Access Compliance Report

Public Rights-of-Way

(Curb Ramps)

Intersection ID: 14851	Main Street: E_WORTHINGTON_AV	Cross Street: PARK_RD	Location: E
ADA ID: 907B73F9B362	Ramp Type: Perp	Initial Pass/Fail: Fail	Overall Compliance: No
			Severity Score: 16.25

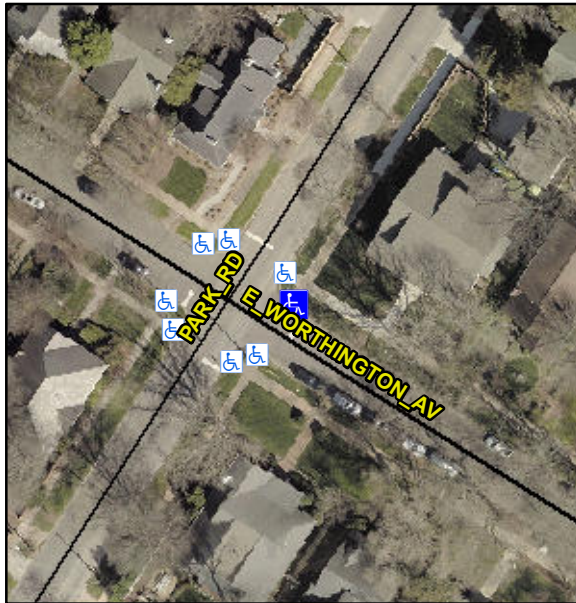
Not Found, R304.5.3, R302.7

Compliance	Description	Data	Compliance	Description	Data
N/A	Ramp Length (in)	63.0	Yes	Ramp Slope (%)	6.4
Yes	Ramp Width (in)	48.0	No	Ramp XSlope (%)	2.9
N/A	Flare Type LT	N/A	N/A	Flare Type RT	N/A
N/A	Flare Slope LT (%)	N/A	N/A	Flare Slope RT (%)	N/A
N/A	Flare Traversable LT?	N/A	N/A	Flare Traversable RT?	N/A
N/A	Landing Length (in)	N/A	N/A	DWS Provided?	N/A
N/A	Landing Width (in)	N/A	N/A	DWS Contrast?	N/A
N/A	Landing Slope (%)	N/A	N/A	DWS Length (in)	N/A
N/A	Landing X Slope (%)	N/A	N/A	DWS Full Width?	N/A
N/A	Landing Curb? (Y/N)	N/A	N/A	DWS Offset (in)	N/A
N/A	Shared Landing?	N/A			
N/A	Gutter Ponding?	Yes	N/A	Gutter Slope (%)	N/A
N/A	Gutter Lip Ht (in)	N/A	N/A	Gutter X Slope (%)	N/A
N/A	Painted X Walk1?	No	N/A	Painted X Walk2?	N/A
	X Walk 1 Direction	To SW		X Walk 2 Direction	N/A
N/A	X Walk 1 Width (in)	N/A	N/A	X Walk 2 Width (in)	N/A
	X Walk 1 Slope (%)	4.6		X Walk 2 Slope (%)	N/A
	X Walk 1 X Slope (%)	0.2		X Walk 2 X Slope (%)	N/A

N/A	Ramp inside XWalk1?	N/A	N/A	Ramp inside XWalk2?	N/A
	Road Slope (%)	N/A	N/A	Clear Space?	N/A
	Road X Slope (%)	N/A	N/A	Clear Space to XWalk (in)	N/A
N/A	Any Obstructions?	N/A	N/A	Storm Grate/Utility Hazard?	N/A
	Obstruction Type			Storm Grate/Utility Type	
		N/A			N/A
		No		Surface Condition? (G/P)	Poor

Remove & Replace Entire Ramp.
